RE: **TECHNICAL MEMORANDUM – SUPPLEMENTAL PROPOSED
MODIFICATION OF APPROVED SOURCE CONTROL MEASURES
ODOT FACILITY IN PORTLAND HARBOR PROJECT AREA**

TO: Jonathan Horowitz, PE, ODOT Project Manager
FROM: Kelsey Harpham, WSP Project Manager
SUBJECT: K22552: OF 16-1 and OF 18-2 SCMs
DATE: 19 March 2025

FIGURE 2A - SITE EXPLORATION PLAN

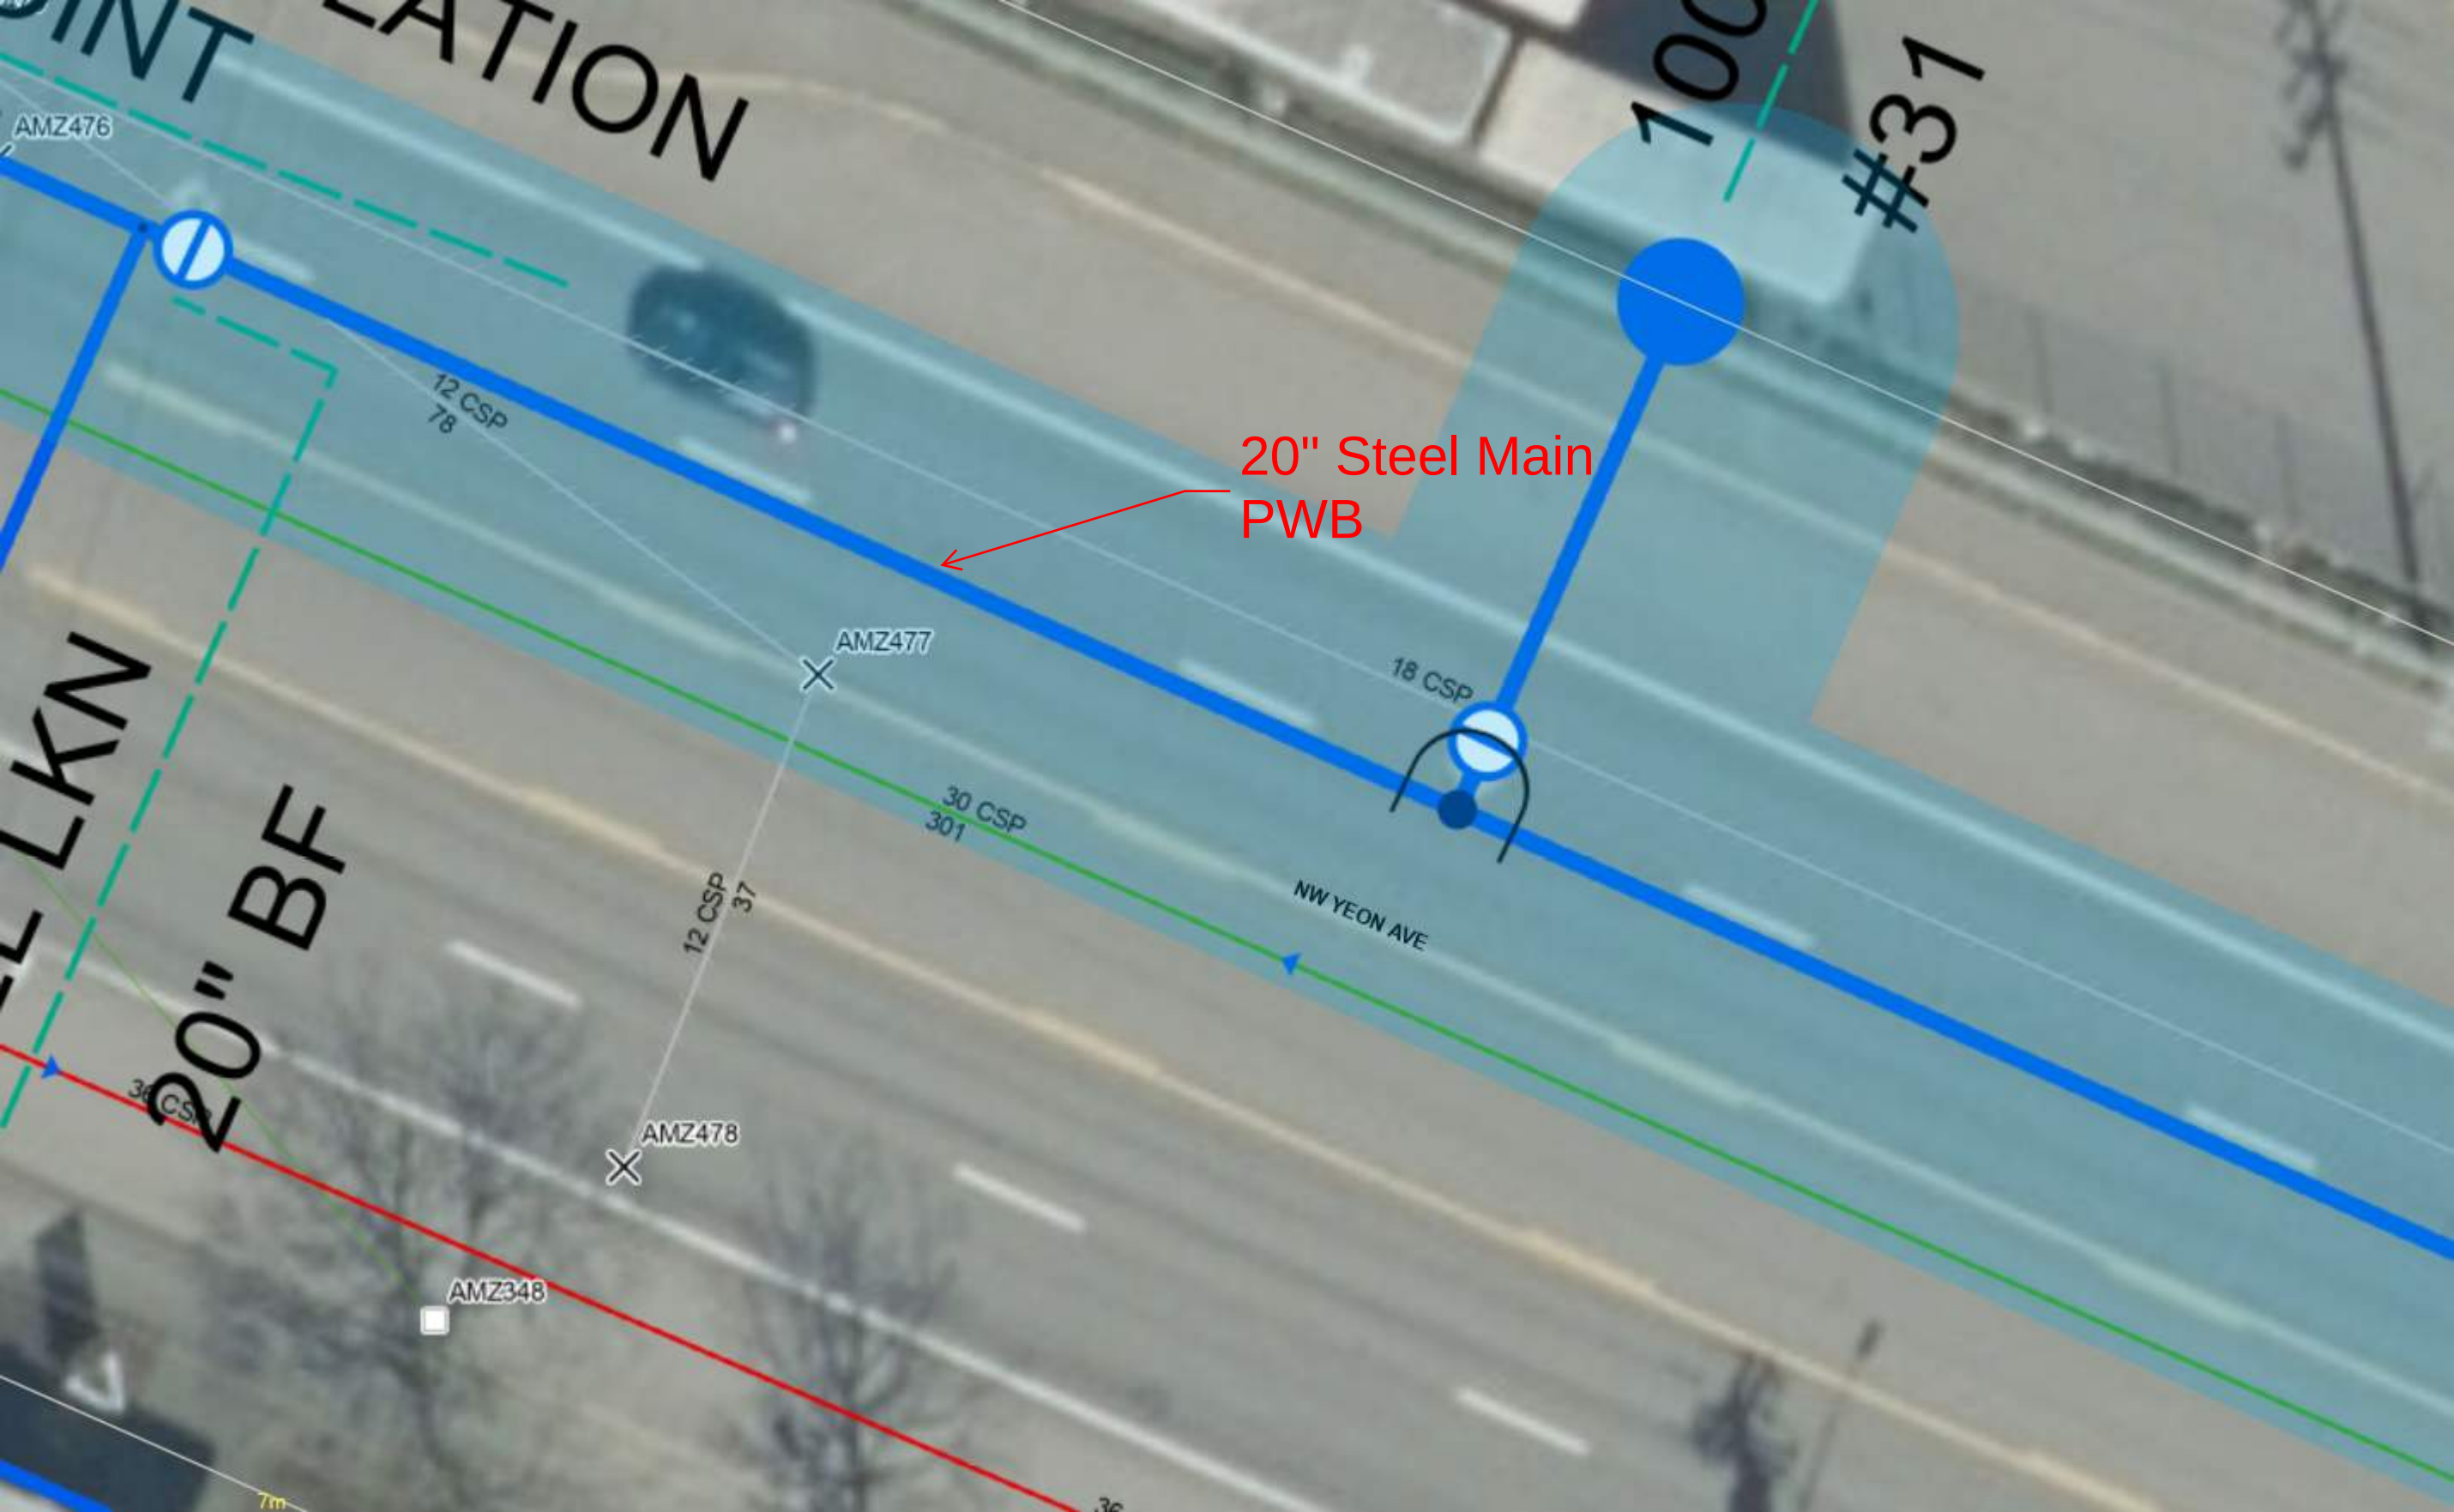
However, geotechnical borings completed as part of design revealed extensive woodchips to approximately 30ft below ground surface elevation. Due to the extent of subsurface woodchips present at this location and structural interventions needed to support PHS structure in the weak woodchip contaminated subgrade, the estimated revised construction cost at this site is \$3,457,200.

The second option, relocation of the PHS structure to the east shoulder of US30, was considered to be the most feasible alternate solution and was evaluated further. Option one was eliminated due to complexity and cost of the micropile foundation, and option 3 was eliminated due to the cost relative to the acres of ODOT treated area.

Based on the information provided above, the design team recommends the *removal of the PHS unit at 16-1, and moving forward with design and construction of 18-2 at the location near Prologis NW in the parking area*. The reduction in treated area is low compared to the cost savings and schedule implications of including the sites at either the 16-1 US30 location or at the intersection of NW35th and NW Yeon Ave. This recommendation is based on cost and schedule impacts as well as site constraints.
